Serial No. 10/605,314  
Filed: 09/22/03  
Page 4 of 7

**Amendments to the Drawings**

Appl. No. 10/605,314  
Amdt. Dated June 1, 2005  
Reply to Office Action of May 23, 2005  
Annotated Sheet Showing Changes

**Fig. 4**

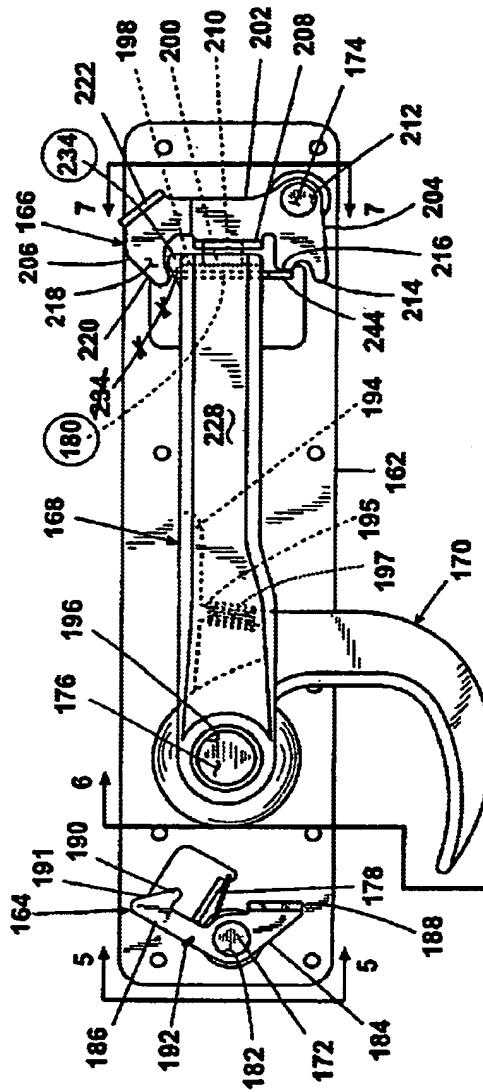
Kindly amend Figure 4 to show the phantom lines for flange 180 and to move the number 234 and the lead line thereto as shown in the enclosed annotated sheet containing Figure 4. A replacement page for the drawing sheet containing FIG. 4 is enclosed herewith for entry by the Examiner.

Fig. 1

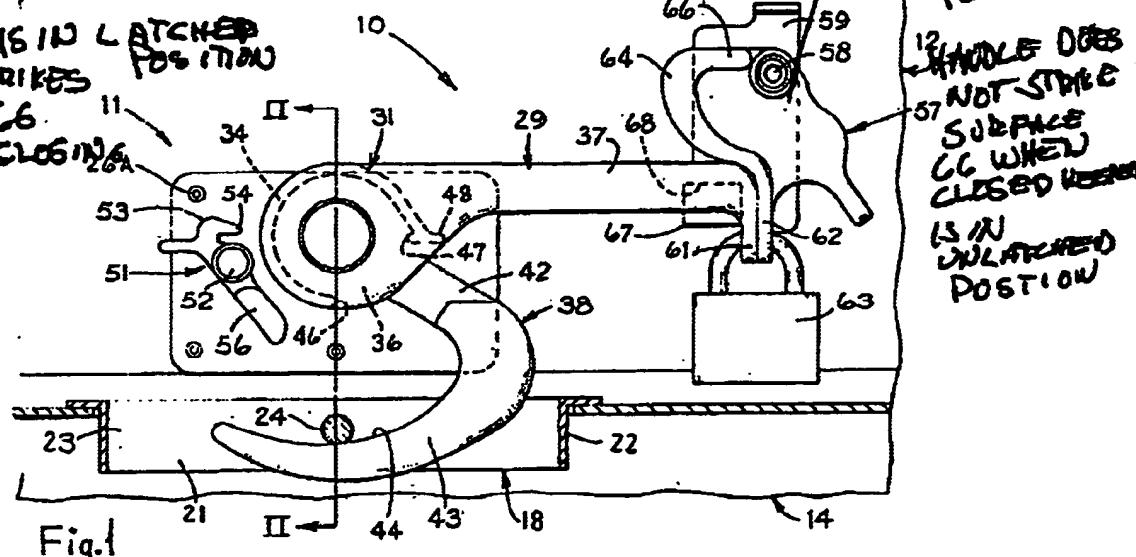
This operation was contrasted with the closed keepers in the Galbreath '164 and the Smith '142 patents. Both of the closed keepers in these patents rotate counterclockwise from the latched to the unlatched positions and will remain in that position when the handle closes in the event that the closed keeper is stuck in the unlatched position illustrated, for example, in FIG. 11 of the Smith '142 patent.

KEEPER IS IN LATCHED POSITION  
HANDLE STRIKES SURFACE OF  
UPON CLOSING. 34

FIG. 11

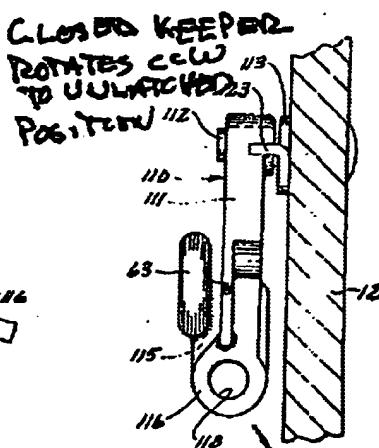
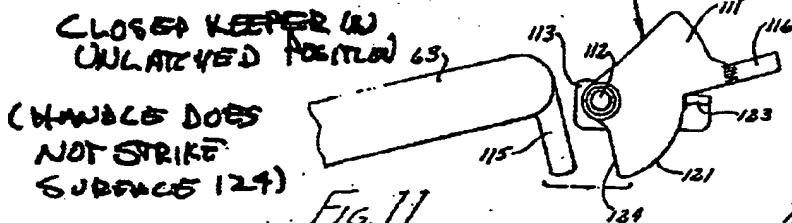
(HANDLE DOES  
NOT STRIKE  
SURFACE 124)

**Fig. 4**

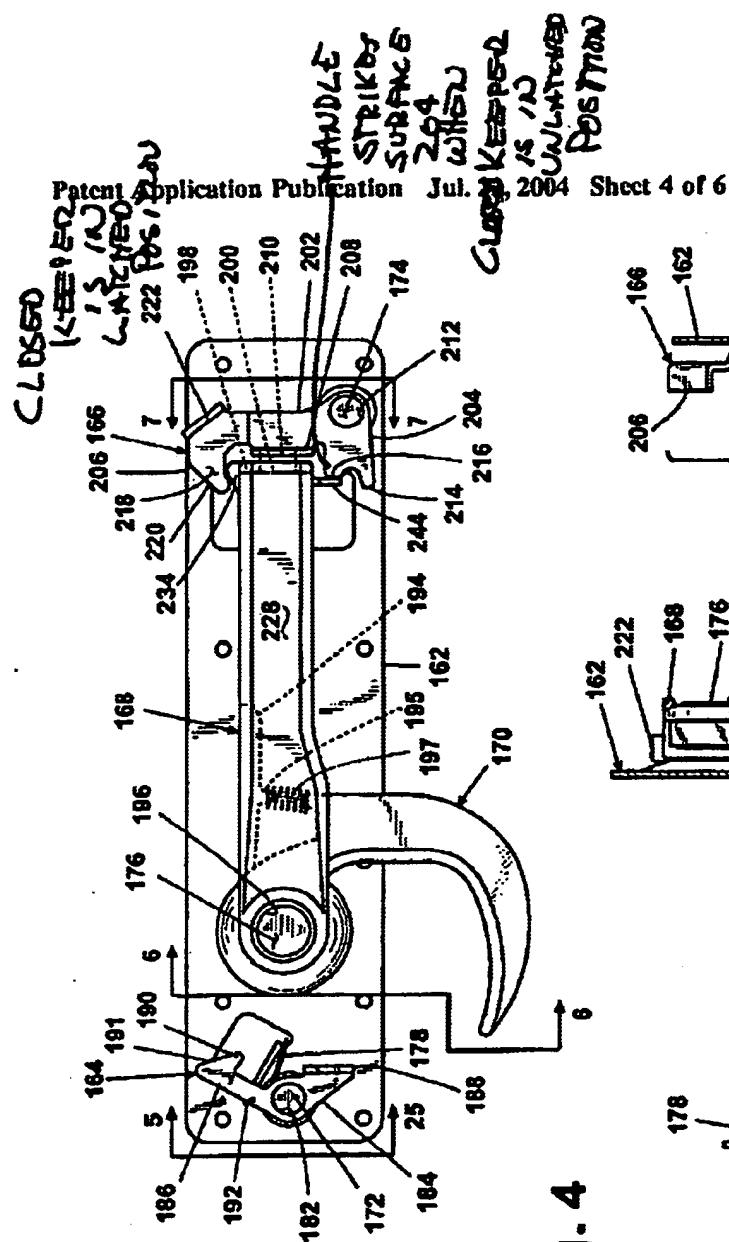
During the course of the interview, these drawings were discussed. The point of the drawings is to illustrate that Applicants closed keeper rotates clockwise about the pin 212 from a latched position to an unlatched position for release of the handle 228. In the event that the keeper is stuck in the unlatched position, the bottom edge of the locking flange 180 of handle 228 will strike the second rotation stop 216 as illustrated in new FIGS. 12 and 12A to force the closed keeper from the unlatched position to the latched position.

During the course of the interview on May 18, 2005, Examiner Lugo raised a question as to the relationship between the handle 228 and the bent flange 180. The Examiner raised a question as to whether the bottom of the handle 228 would rest on surface 248 of the bent flange 180. At the time of the interview on May 18, 2005, Applicants' attorney agreed to review the specification and drawing to answer this question.

During the course of the telephone interview on May 19, 2005, Applicants' attorney explained to Examiner Lugo, especially with reference to FIGS. 9 and 10 of the Applicants' drawings, that the handle plate 228 was positioned distal from the mounting plate 162 and outside of the bent flange 180. The locking flange 198 of the handle 168 is sandwiched between the bent flange 180 and the locking flange 208 of the closed keeper when the handle is in the closed position so that a padlock can be placed through the openings in each of these three elements. The Examiner understood this explanation and agreed that the drawings showed this feature.
